Subject: RE: Shear Wall holddown connection
From: Grant Wolter <gwolter@reigstad.com>
Date: 30/12/2019, 15:53
To: Luis C. Pérez Tato <l.pereztato@xcingenieria.com>
CC: 'Ana Ortega' <ana.ortega@xcingenieria.com>, Ryan Schultz <ryan.schultz@openingdesign.com>

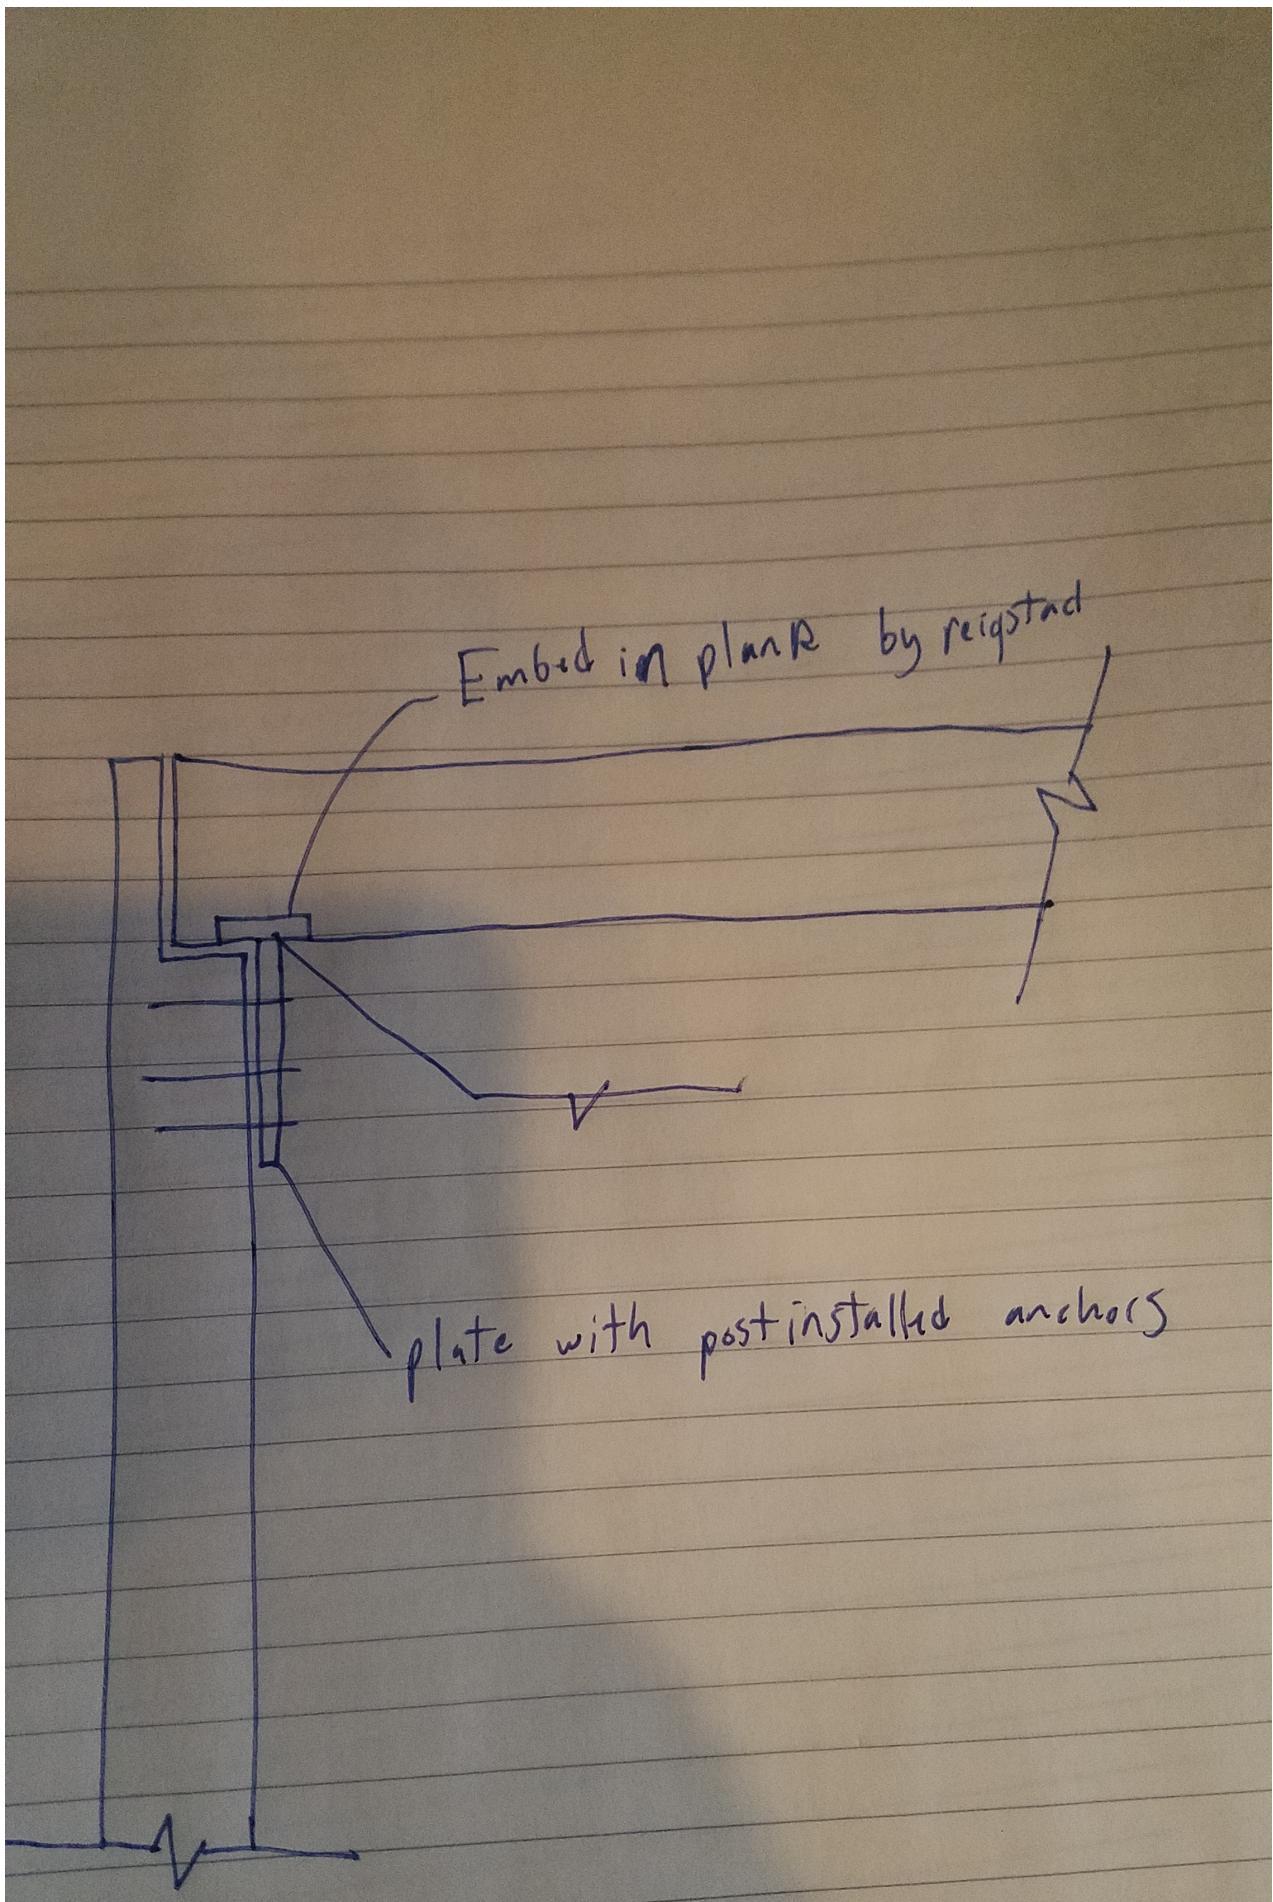
If that is the case the dead load of the plank will not be enough to resist uplift from the holddown. If we provide an embed plate in the bottom of this plank on both ends could you design a plate for the wall to hold it down? I am making that piece a solid slab which will have an end reaction dead load of 8 kips. That will leave us with 5.3 kips of uplift needing to be resisted by a connection to the wall.

What is your plan for the shear wall at Grid 1, 0-A.1(See attached)? You have large uplift and no detail for how it will attach. Will you be anchoring your holddown directly into the wall or attaching to our plank first? If you attach the holddown to our plank we will need to tie it down to the walls to prevent uplift.

Attached is a sketch of what I was picturing for this connection. I am guessing the wall is already poured so we will need to use anchor bolts or epoxied anchors. Let me know if you have any questions.

My intention is to fix it to the planks, if I'm not mistaken, the space over the wall itself will be occupied by the ordinary studs of the facade wall and the four hold down studs of the shear wall itself, therefore the anchor needs to be fixed to the plank.
